DISTRIBUTING CO., INC.

SERVICE NOTE KDK 2025A MK11

SERVICE NOTES/HINTS AND KINKS

SERVICE NOTES/HINTS AND KINKS

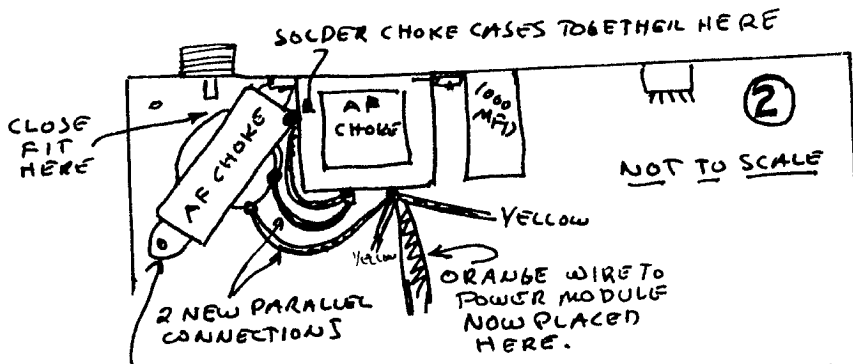
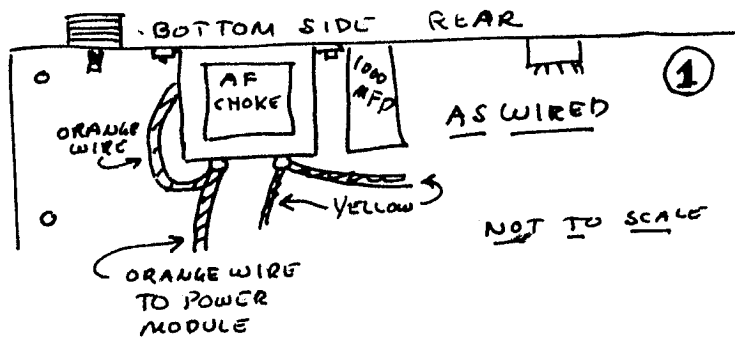
Drawing #1 shows the unit as it comes from the factory. Note that the lugs on the left of the AF choke have two orange wires. One of the wires on the far left goes to the switch. The other orange wire goes to the power module. This wire will be moved to the right lug as shown in figure #2.

Drawing #2 The second AF choke is placed on the chassis. Rather close fit. It is suggested that the cases of the two chokes be soldered together where they touch. Scrape the enamel from the surfaces to be soldered and tin each first using a good hot iron. The mounting tab on the far left should also be cleaned and soldered first and the protruding bolt as well. Then they will solder well and hold. A longer bolt through the low pass filter unit with a nut on the end holding the new choke in place is to be preferred over soldering the tab to the bolt. Two wires, about 18 gauge are now used to wire the lugs of the two chokes in parallel as per drawing. Only the orange wire from the power module is moved and is now soldered to the right lug on the original choke.

Drawing #3 Place a .068 mfd mylar capacitor of at least 50 volt rating on the wire protruding from the power module which has the orange wire coming from the AF filters and solder in place. Connect the other end of the capacitor to the ground lug bolted on the left hand mounting tab of the power module.

Drawing #4 shows the speaker mounting and how it is turned 90 degrees.

SOLDER CASE OF CHOKE TO PROTRUDING BOLT OR - USE LONGER BOLT THRU LO PASS FILTER BOARD AND PUT A NUT ON THIS END TO HOLD CASE OF CHOKE TO CHASSIS

*BE SURE MODER STICKS TO BOLT AND CHOKE FRAME. USE FILE OR SANDPAPER TO CLEAR SURFACE BEFORE SOLDERING.
